Scott L. Batson Vice President Oconee Nuclear Station

ONS-2014-105

Subject: License Amendment Request for Adoption of Technical Specification Task Force (TSTF) – 513, Revision 3, "Revise PWR Operability Requirements and Actions For RCS Leakage Instrumentation;" License Amendment Request No. 2011-03

LICENSE AMENDMENT REQUEST NO. 2011-03

B 3.4.15 RCS Leakage Detection Instrumentation

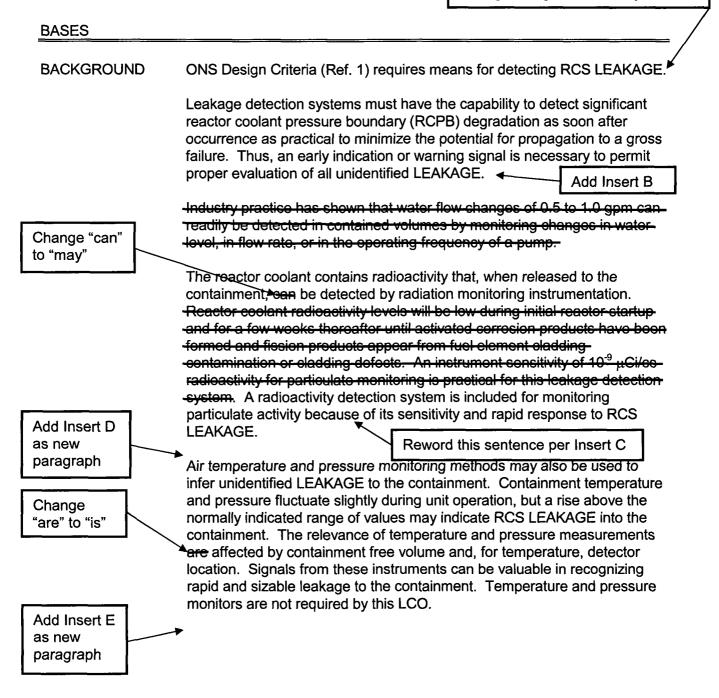
Insert: "Although ONS is not committed to Regulatory Guide 1.45, Revision 0 (Ref. 2) of the RG describes acceptable methods for setting leakage detection systems."

Insert B

In addition to meeting the OPERABILITY requirements, the monitors are typically set to provide the most sensitive response without causing an excessive number of spurious alarms.

Insert C

Radioactivity detection systems are included for monitoring both particulate and gaseous activities because of their sensitivities and rapid responses to RCS LEAKAGE.

ACTIONS <u>B.1.1, B.1.2, and B.2</u> (continued)

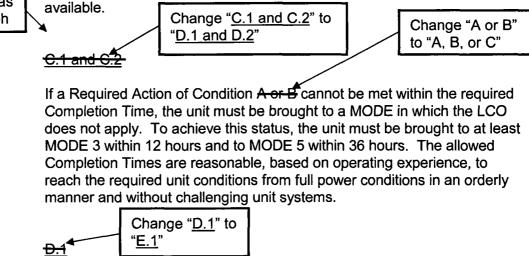
Add Insert G as new paragraph

If both required leakage detection instruments are inoperable, no automatic means of monitoring leakage are available, and immediate plant shutdown in accordance with LCO 3.0.3 is required.

Insert G:

C.1 and C.2

With containment normal sump level indication inoperable, the only means of detecting LEAKAGE is the required containment atmosphere radioactivity monitor. A Note clarifies that this Condition is applicable when the only OPERABLE monitor is the containment atmosphere gaseous radioactivity monitor. The containment atmosphere gaseous radioactivity monitor. The containment atmosphere gaseous radioactivity monitor typically cannot detect a 1 gpm leak within one hour when RCS activity is low. In addition, this configuration does not provide the required diverse means of leakage detection. Indirect methods of monitoring RCS leakage must be implemented. Grab samples of the containment atmosphere must be taken and analyzed to provide alternate periodic information. The 12 hour interval is sufficient to detect increasing RCS leakage. The Required Action provides 7 days to restore another RCS leakage monitor to OPERABLE status to regain the intended leakage detection diversity. The 7 day Completion Time ensures that the unit will not be operated in a degraded configuration for a lengthy time period.
